AMENDMENT NO. 4 (11/2022)

AIS-099

**Approval of Vehicles with regards to the Protection of the Occupants
in the event of a Lateral Collision**

AMENDMENT NO. 3 (02/2019)

Figure 1 Measurement of V_b , V_1 , V_2

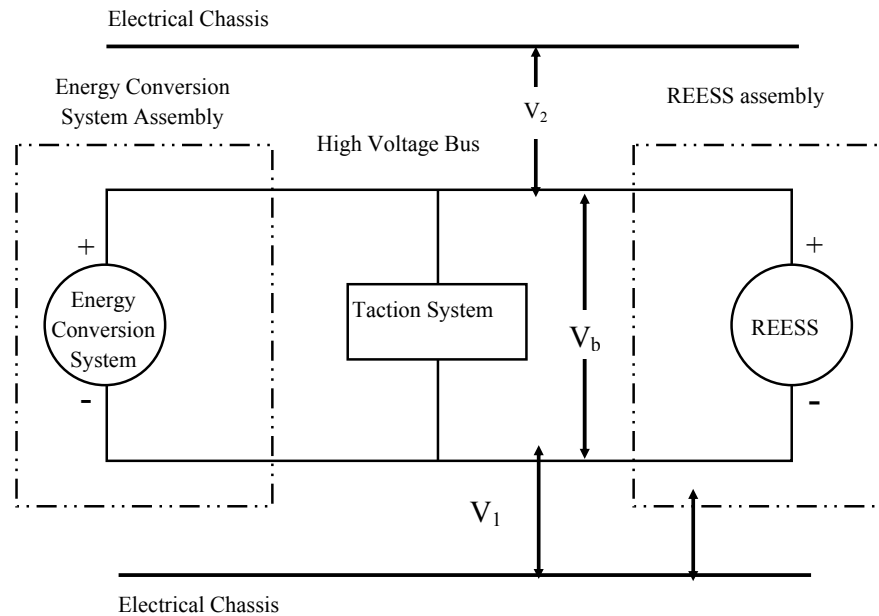
14. Page No. 92/92, Add new section “Annex 7” and substitute title “Annex 8” to “Annex 7”(former) as below:

Before the vehicle impact test conducted, the high voltage bus voltage (V_b) (see figure 1) shall be measured and recorded to confirm that it is within the operating voltage of the vehicle as specified by the vehicle manufacturer.

After the impact test, determine the high voltage bus voltages (V_b , V_1 , V_2) (see figure 1).

Figure 2
E.g. measurement of high voltage bus energy stored in X-capacitors

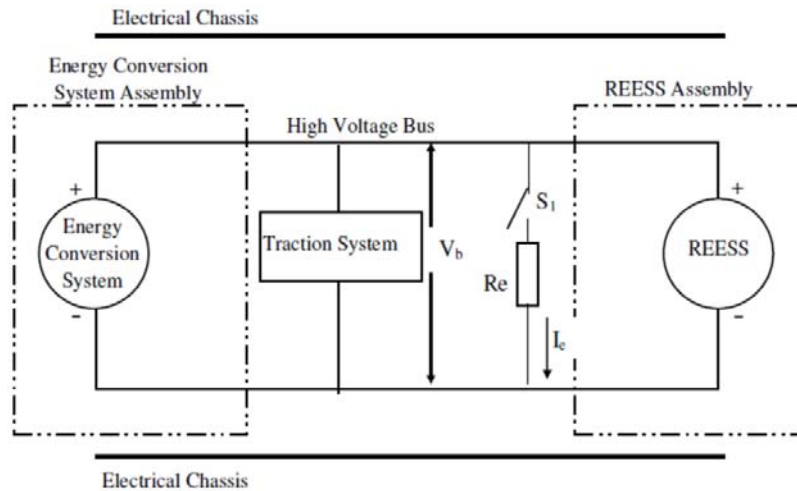
Prior to the impact a switch S_1 and a known discharge resistor R_e is connected in parallel to the relevant capacitance (ref. figure 2).

Figure 3 Measurement of V_1 '

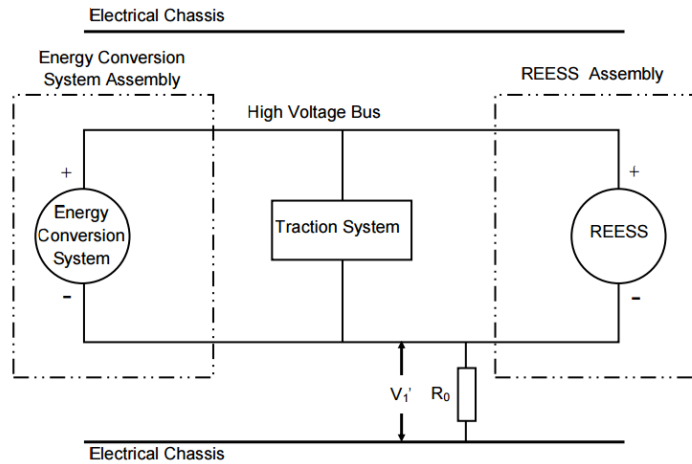
If V_1 is greater than or equal to V_2 , insert a standard known resistance (R_o) between the negative side of the high voltage bus and the electrical chassis. With R_o installed, measure the voltage (V_1') between the negative side of the high voltage bus and the vehicle electrical chassis (see figure 3). Calculate the isolation resistance (R_i) according to the formula shown below.

Figure 4 Measurement of V_2'

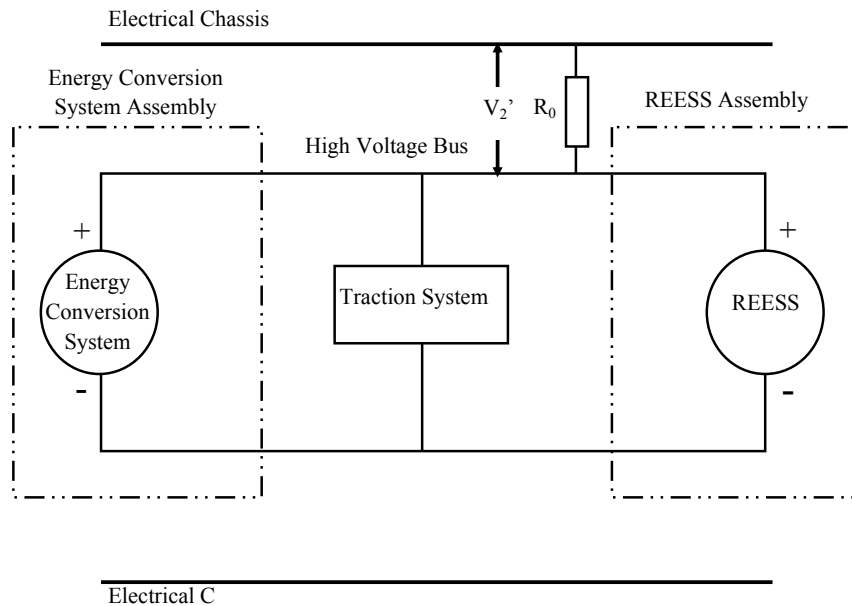
If $V_2 > V_1$, insert a standard known resistance (R_0) between the positive side of the high voltage bus and the electrical chassis. With R_0 installed, measure the voltage (V_2') between the positive side of the high voltage bus and the electrical chassis (see figure 4).

Figure 1 Jointed test finger

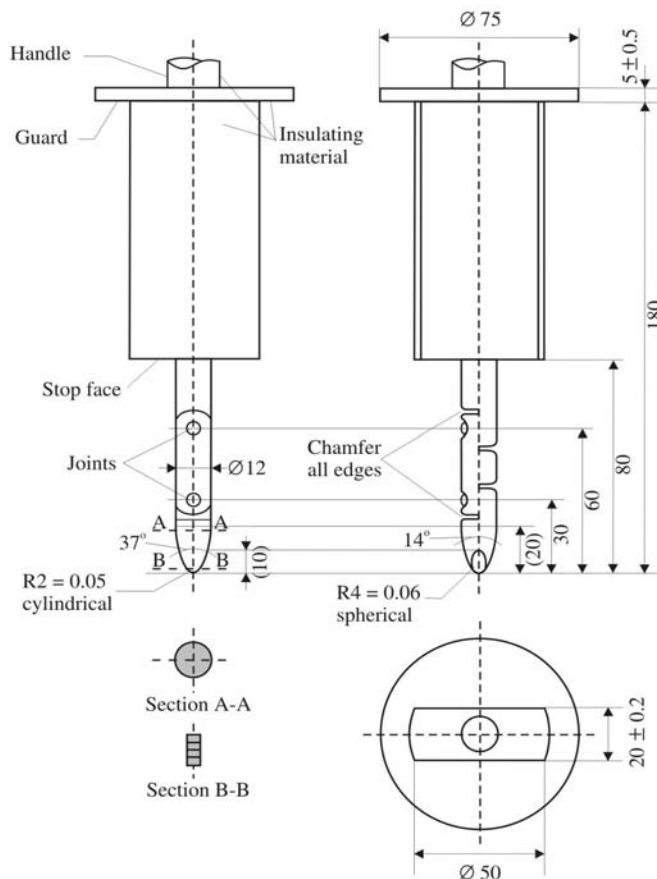
The Jointed Test Finger described in Appendix 1 figure 1 shall be inserted into any gaps or openings of the physical protection with a test force of $10 \text{ N} \pm 10 \%$ for electrical safety assessment. If partial or full penetration into the physical protection by the Jointed Test Finger occurs, the Jointed Test Finger shall be placed in every position as specified below.

The requirements of paragraph 5.3.6.1.3. shall be considered to be met if the Jointed Test Finger described in Annex 7, Appendix 1, figure 1 is unable to contact high voltage live parts.
